Addendum to Mitigated Negative Declaration

Addendum Date: September 20, 2012
Case No.: 2010.0256E
Project Title: Fisherman's Wharf Public Realm Plan
FMND Adopted: August 30, 2011
Project Sponsor: San Francisco Planning Department, Citywide Policy Planning
Neil Hrushowy, Urban Designer/Planner – (415) 558-6471
Lead Agency: San Francisco Planning Department
Staff Contact: Monica Pereira – (415) 575-9107
monica.pereira@sfgov.org

FIGURE 3: JEFFERSON STREET IMPROVEMENTS
MODIFIED PROJECT ANALYZED IN THE ADDENDUM

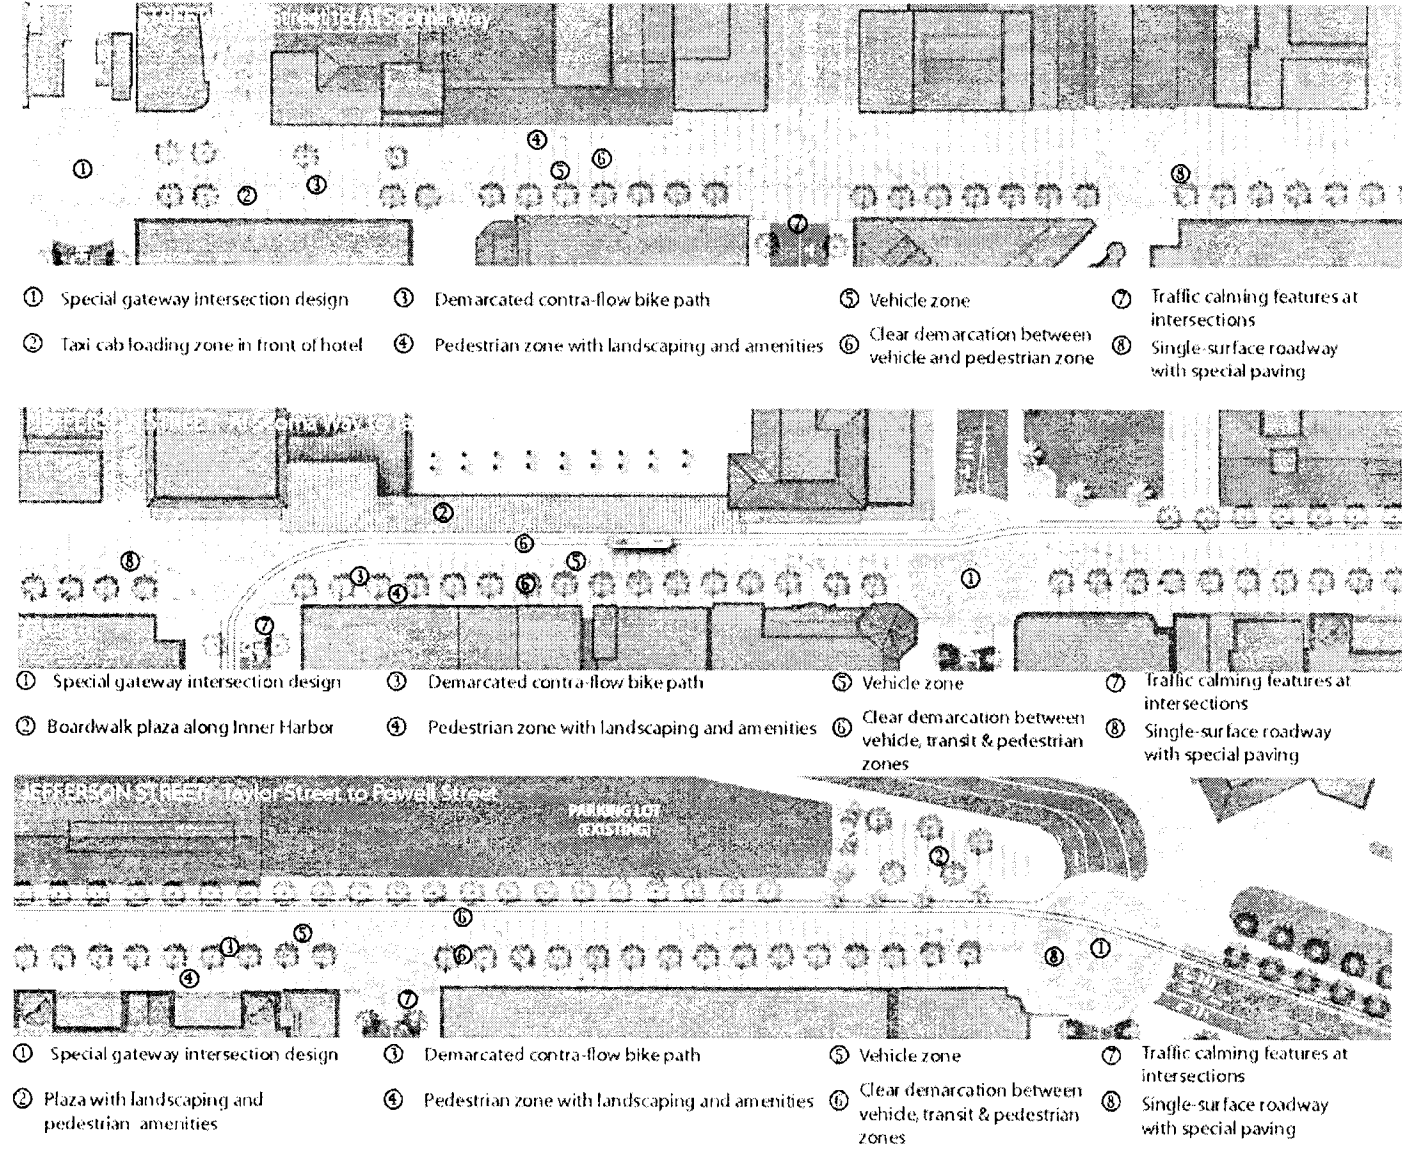
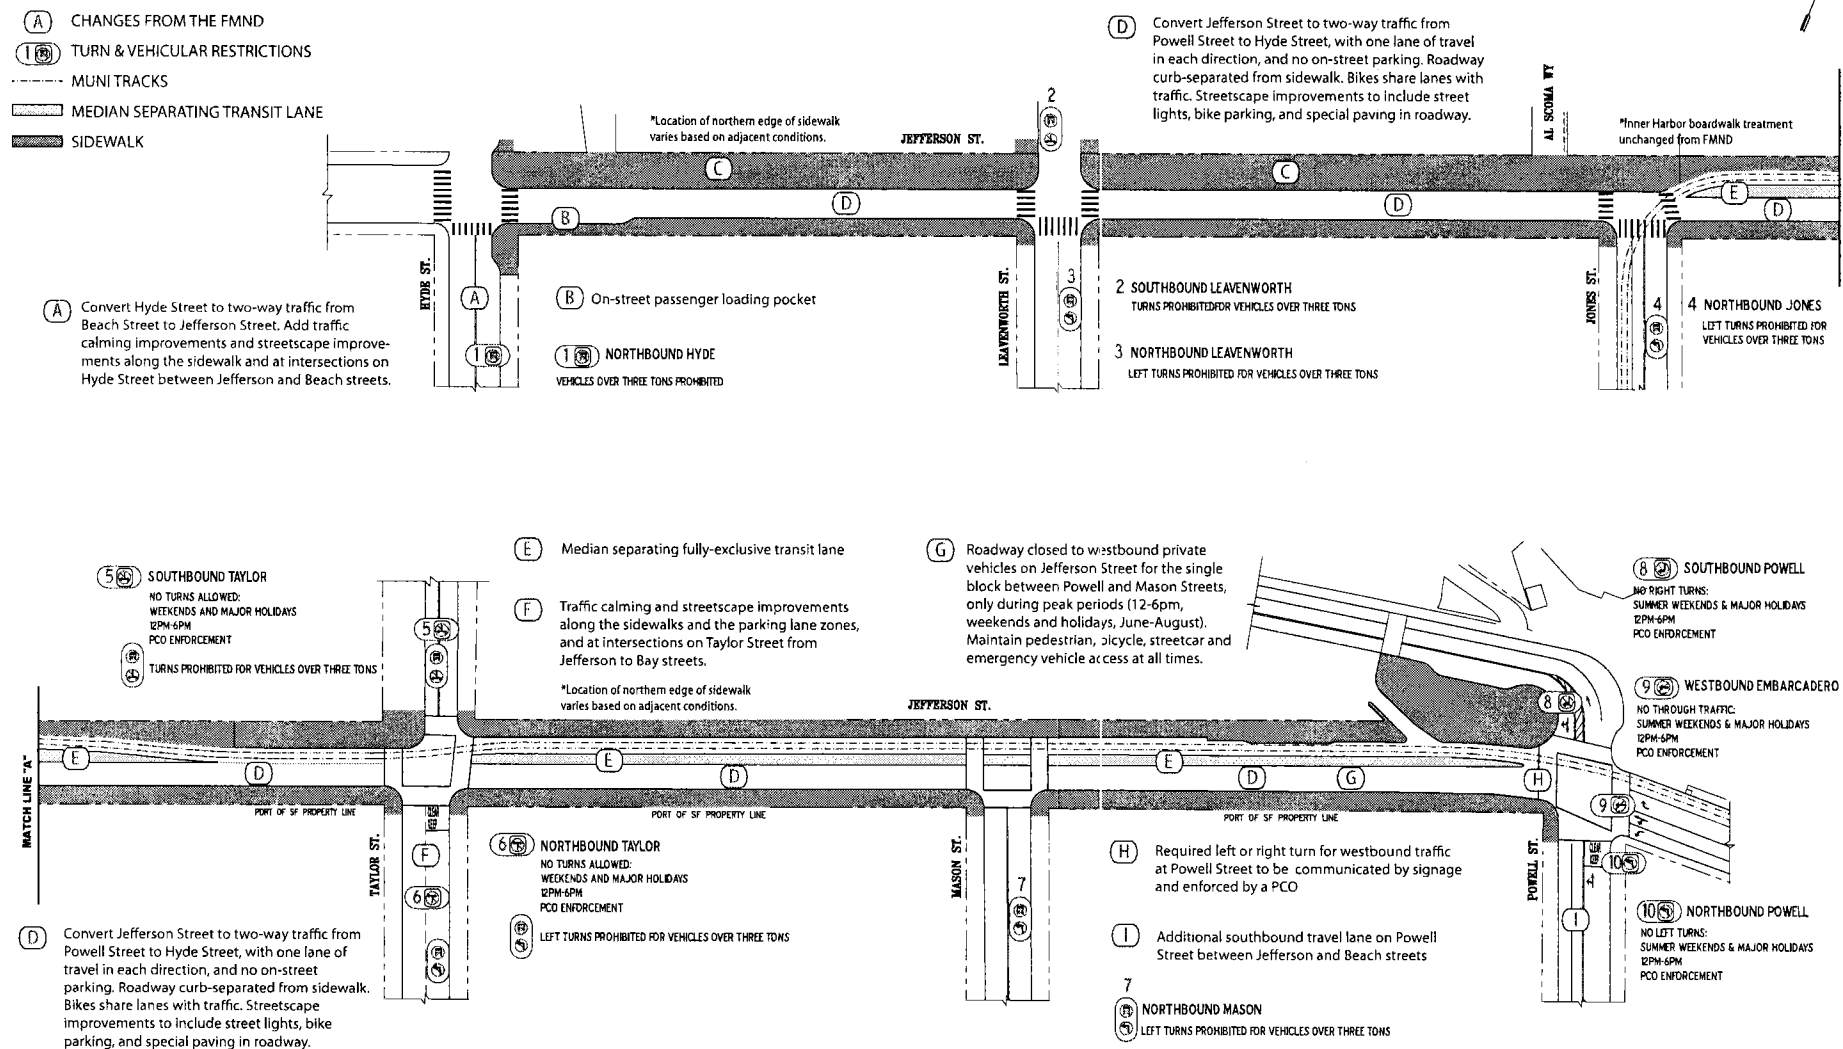
Differing from the FMND project, the modified project would convert Jefferson Street from one-way travel to two-way travel. The modified project would reconfigure all intersections to accommodate the conversion from one-way to two-way traffic on Jefferson Street. Bicycles would travel in both directions sharing the lane with other vehicles. On the block between Taylor and Jones streets, sharrows would direct westbound bicycles to avoid the westbound streetcar tracks.⁵ Also, the modified project would establish a new 15 mph speed limit between Powell and Hyde streets.

Also, unlike the FMND project, the modified project would not reconstruct the streetcar tracks on the western half of the block of Jefferson Street between Taylor and Jones streets. Similar to the FMND project, the modified project would upgrade the existing transit lane into a fully-exclusive facility. The modified project would construct a planted median between the existing tracks and westbound travel

lane on Jefferson Street between Powell and Jones streets, whereas the FMND project did not include a planted median. Streetcar tracks, stops and related infrastructure would not be modified.

Additionally, the modified project differs from the FMND project in that the modified Jefferson Street design would create a 24-foot wide roadway with special paving and 15-foot concrete sidewalks on both sides of the street. Between Jones and Hyde streets, where there are no streetcar tracks, there would be a 15-foot flexible zone on the north side to accommodate outdoor dining and other pedestrian amenities. When a vehicle has pulled to the curb to unload goods or passengers, vehicles passing through would need to maneuver into opposing traffic to overtake the stopped vehicle (Please see **Table 1, Item No. 6**).
